Re: Notice of Construction (NOC) for the Bulk Vitrification Test and Demonstration Facility and Partial Retrieval of Tank 241-S-109, Revision 1 Approval Order

Enclosed is the Dangerous and/or Mixed Waste Research, Development, and Demonstration Permit for the Demonstration Bulk Vitrification Facility (DBVS Facility), west of the 241-S Tank Farm in the 200 West Area of the Hanford Site. The Permit has been issued to the United States Department of Energy (USDOE), Office of River Protection (ORP) and CH2M HILL Hanford Group, Inc. (CH2M) in accordance with the applicable provisions of the Hazardous Waste Management Act, Chapter 70.105 Revised Code of Washington (RCW), and the regulations promulgated hereunder in Chapter 173-303 Washington Administrative Code (WAC). Also enclosed is the Fact Sheet for the Permit. Additional copies of the Permit will be provided on CD-ROM, if requested.

## **FACT SHEET**

Figure 1-2. Proposed Project Schedule

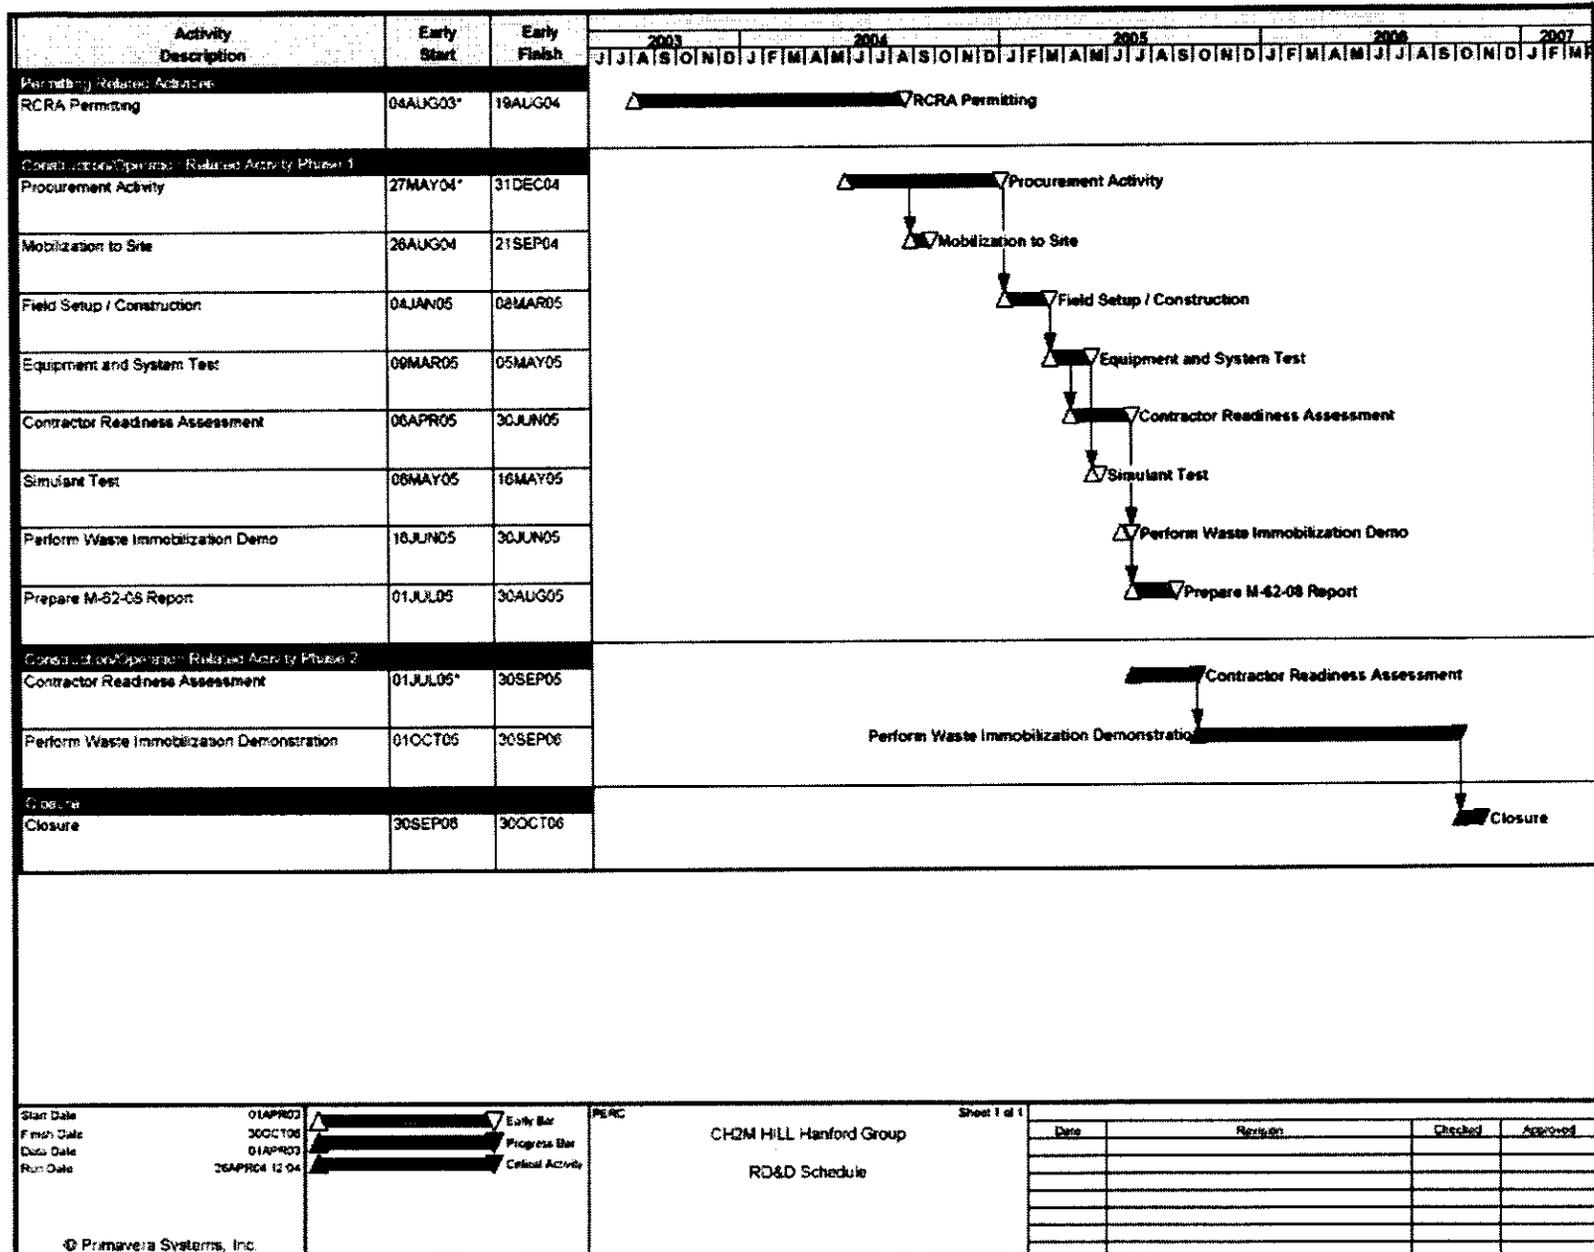
7 Figure 1-2 shows the proposed schedule for the RD&D project. Phase 1 is expected to last one  
8 to three months. The interval between the completion of Phase 1 and start of Phase 2 is  
9 approximately three months and is based on the best current estimate of tasks to be performed  
10 during that interval. Operations are expected to last one operating year and may require more  
11 than one calendar year to complete.
